NOVI TEN TOWNHOMES JSP 14-18

Public hearing at the request of Toll Brothers for approval of the Preliminary Site Plan, Woodlands Permit, Wetlands Permit and Storm water Management Plan. The subject property is located in Section 26, east of Novi Road and south of Ten Mile Road. The applicant is proposing to construct a 93 unit multiple-family residential development on a 20.09 acre property.

PLANNING REVIEW

Review based on Revised Preliminary Site Plan on September 10, 2015

Figure 1. City of Novi Regulated Wetland & Woodland Map (approximate property boundary shown in red). Regulated Woodland areas are shown in green and regulated Wetland areas are shown in blue).

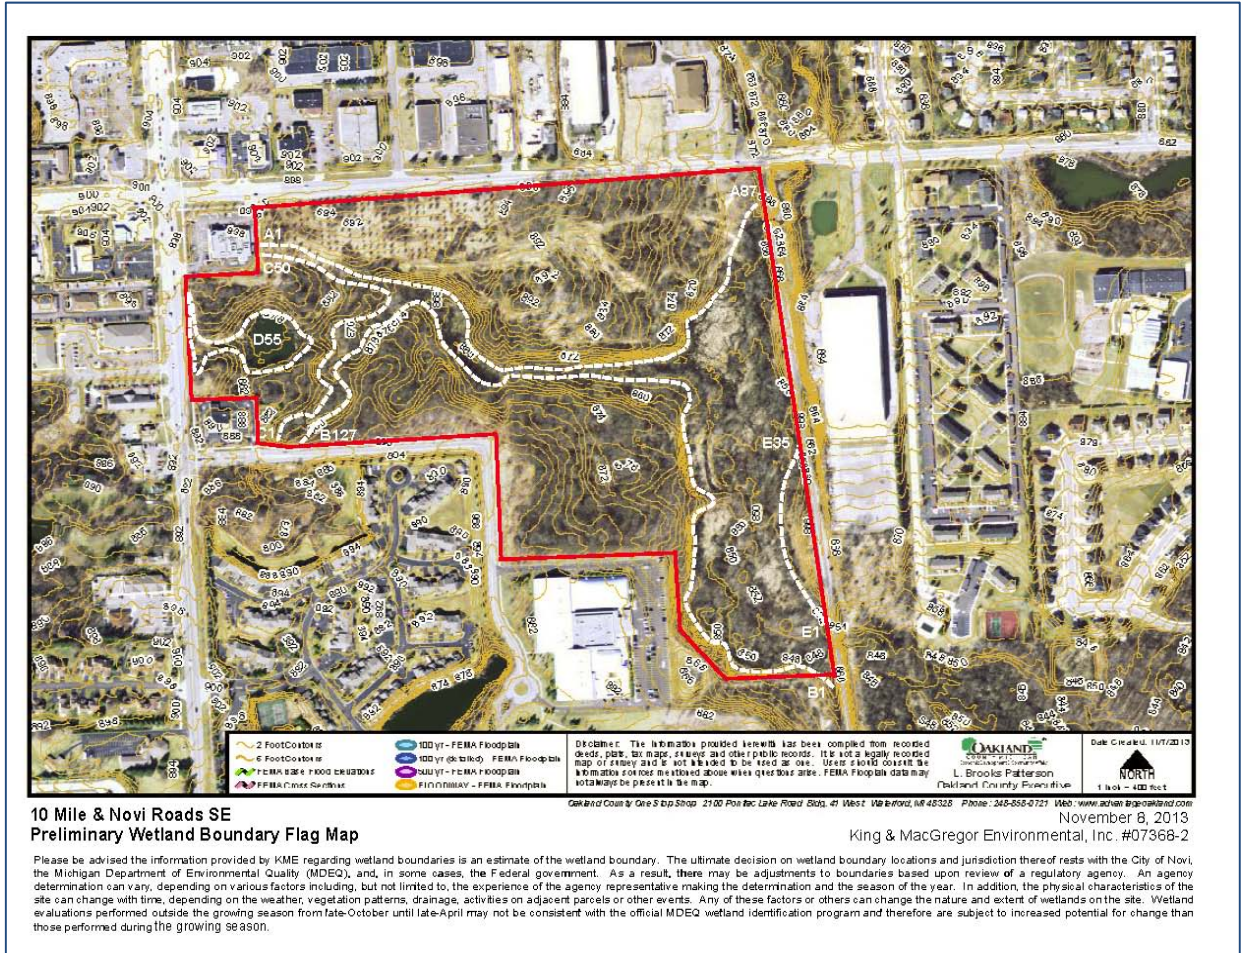
The proposed development is located east of Novi Road and north of Nick Lidstrom Drive, Section 26. The Plan appears to propose the construction of 21 multi-family residential site buildings, associated roads and utilities, and a storm water detention basin. The proposed project site contains several areas of City-Regulated Wetlands and is adjacent to Chapman Creek (see Figures 1 & 2).

The *Preliminary Site Plan* (Sheet 2) indicates areas of wetland surrounding the proposed development site. As noted, these wetland areas were delineated by King & MacGregor Environmental, Inc.

While the Plan includes proposed impacts to on-site wetland buffer, the Applicant has made an attempt to minimize proposed wetland disturbance. The following table summarizes the existing wetlands and the proposed wetland impacts as listed on the *Preliminary Site Plan* (Sheet 2):

Figure 1. City of Novi Regulated Wetland & Woodland GIS Coverage Map (approximate property boundary shown in red). Regulated Woodland areas are shown in green and regulated Wetland areas are shown in blue).

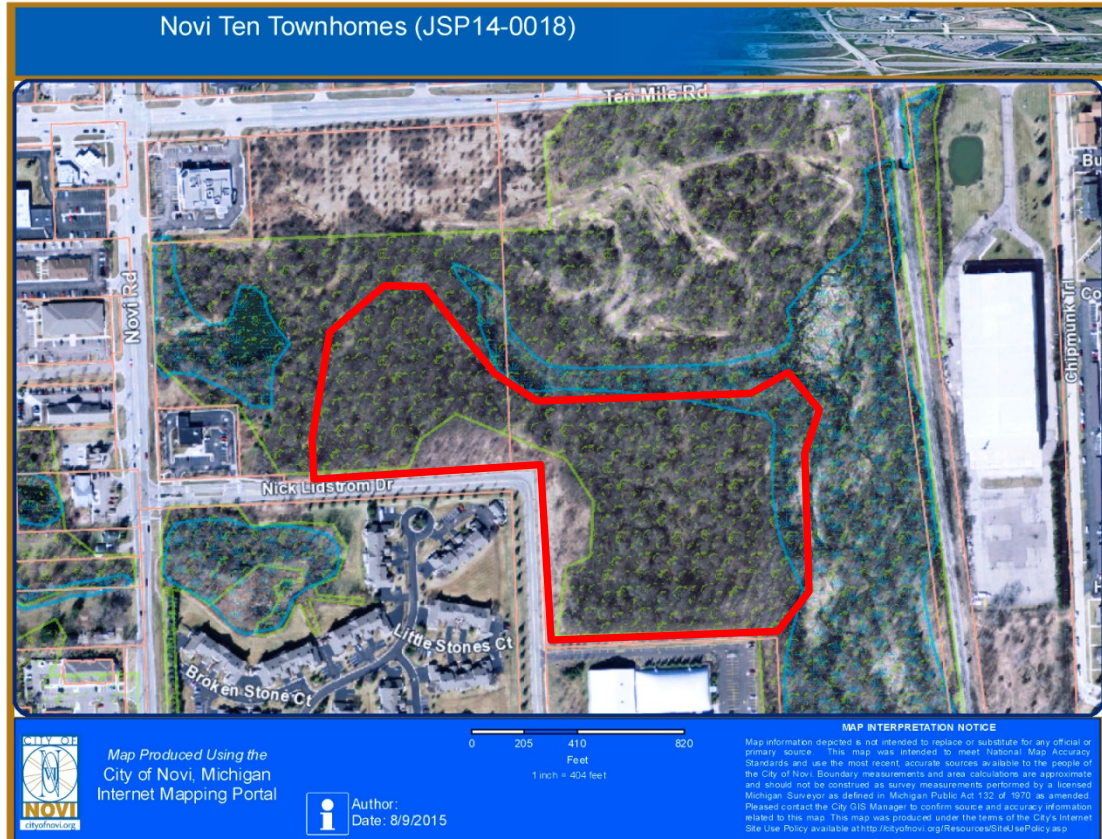
ECT previously visited the site for the purpose of a woodland evaluation. The proposed development is located east of Novi Road and north of Nick Lidstrom Drive, Section 26. The Plan appears to propose the construction of 21 multi-family residential site buildings, associated roads and utilities, and a storm water detention basin. The proposed project site contains a significant amount of City-Regulated Woodland area and is adjacent to areas of existing wetland and Chapman Creek (see Figure 1), a tributary of the Rouge River.

As noted above, the proposed project site contains a significant area of regulated woodland (see Figure 1). The majority of the proposed development limits lie within areas of existing City-Regulated Woodland. The highest quality woodlands on site are found in the northwestern portion of the project (located north of Nick Lidstrom Drive). The site is surrounded by areas of City- and MDEQ-regulated wetlands. The proposed site development will involve a significant amount of impact to regulated woodlands and will include a significant number of tree removals.
